CITY OF CAMBRIDGE
BUILDING DIVISION

MODEL: CHERRY 2

CHERRY 2 (GR)
ELEVATION 1 & 2

TITLE PAGE

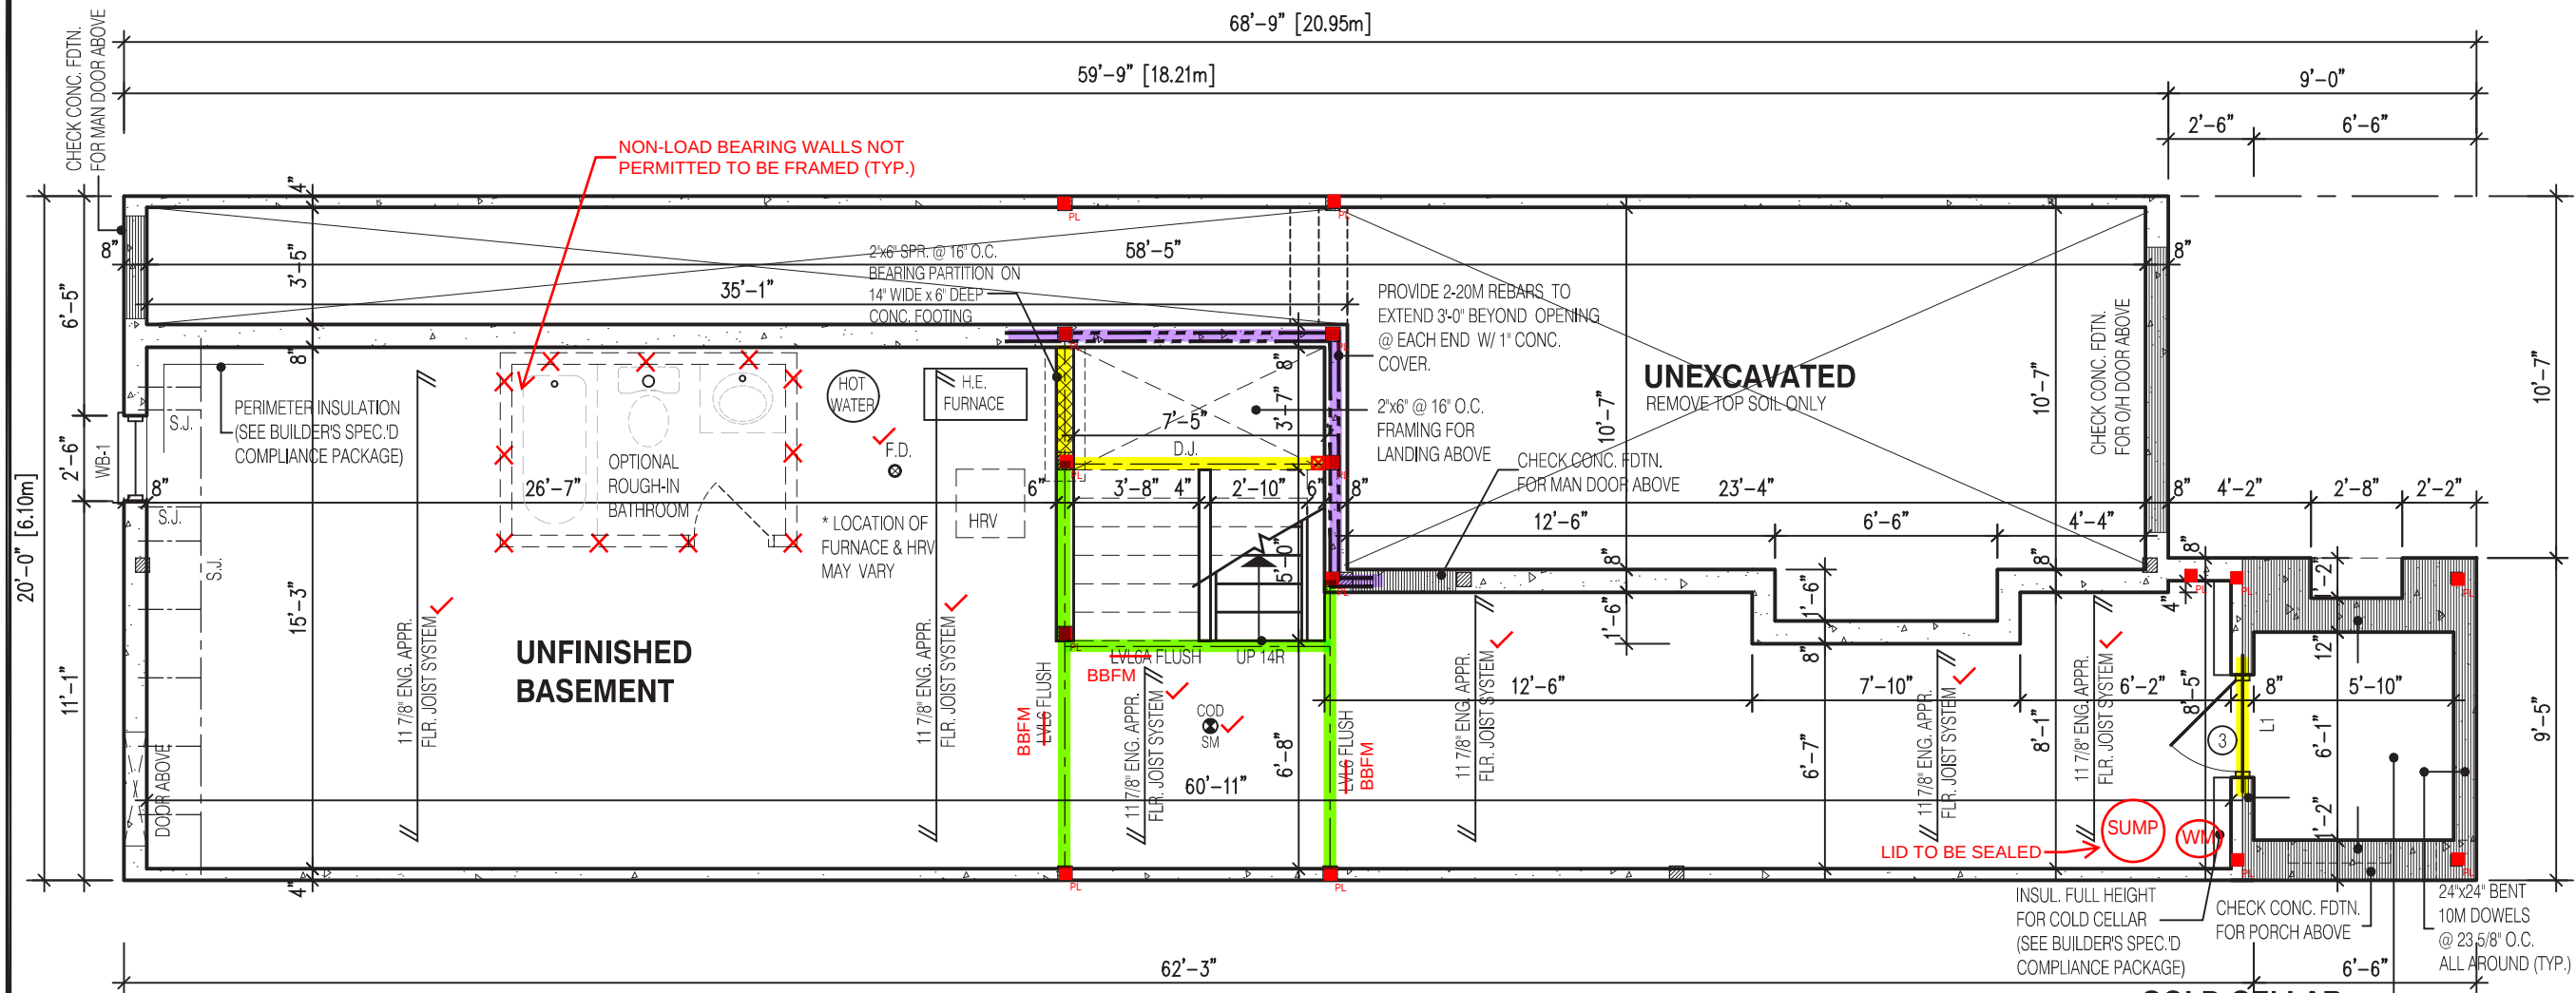
A SEPARATE PERMIT IS REQUIRED FOR THE FINISHING OF ALL ROUGHIN PLUMBING FIXTURES

A CARBON MONOXIDE DETECTOR SHALL BE LOCATED ADJACENT TO SLEEPING AREAS

REINFORCING REQUIRED IN FOUNDATION WALL OR PORCH SLAB SHALL BE REVIEWED PRIOR TO POURING CONCRETE (see inspector)

PROVIDE P.ENG APPROVED TRUSS & FLOOR DRAWINGS AND SPECIFICATIONS TO BUILDING INSPECTOR AT FRAMING INSPECTION

INSTALLATION OF FLUSH STEEL BEAMS SHALL CONFORM TO THE REQUIREMENTS OF 9.23.9.2.(3), (4) & (5)

P.ENG SOILS REPORT MAY BE REQ'D TO CONFIRM BEARING CAPACITY OF SOILS. SEE FIELD INSPECTOR

FINAL GRADING CERTIFICATE REQ'D BEFORE FINAL INSPECTION SIGN-OFF

ENERGY PERFORMANCE LABELS FOR ALL GLAZING PRODUCTS IDENTIFYING THE CERTIFIED VALUES SHALL REMAIN ON FOR REVIEW DURING CONSTRUCTION

BSMT PLAN EL- 1 & 2
BARLASSINA CONSTRUCTION
CITY OF CAMBRIDGE

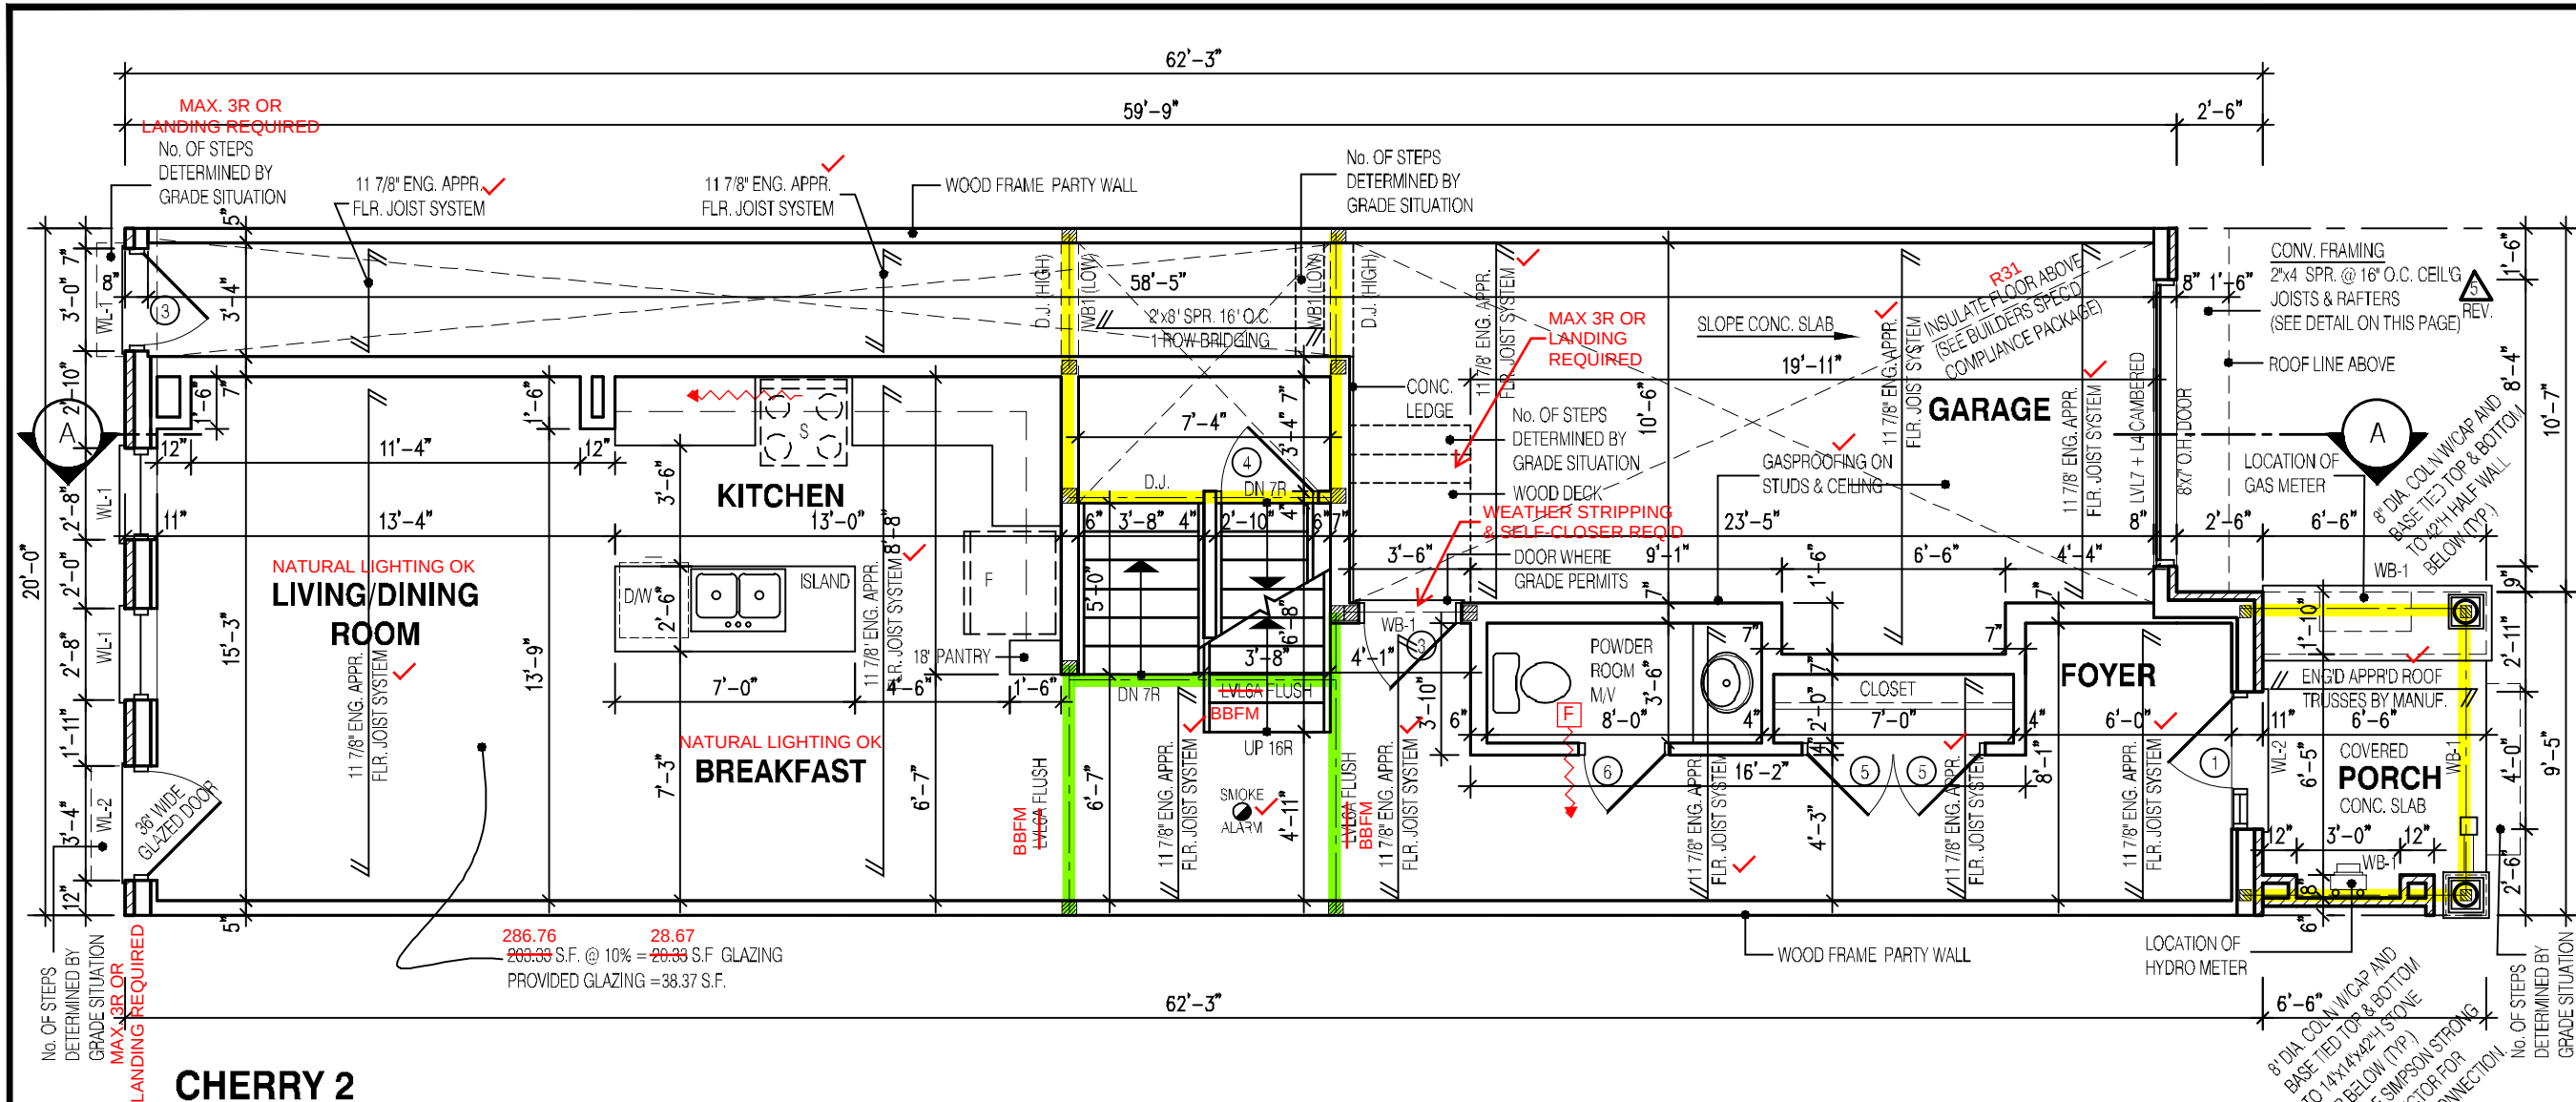
VERIFY WATER METER AND DWHR
UNIT LOCATION WITH INSPECTOR

SPRAY FOAM/RIGID INSULATION TO BE
PROTECTED AS PER 9.10.17.10.(1)

WATER METER TO BE INSTALLED WITHIN 2m
(6'-6") FROM THE POINT THE WATER SERVICE
PIPE MEETS THE BUILDING LINE

REQUIRED CONTINUOUS INSULATION
CANNOT BE INTERRUPTED BY FRAMING
MEMBERS SUCH AS STUDS
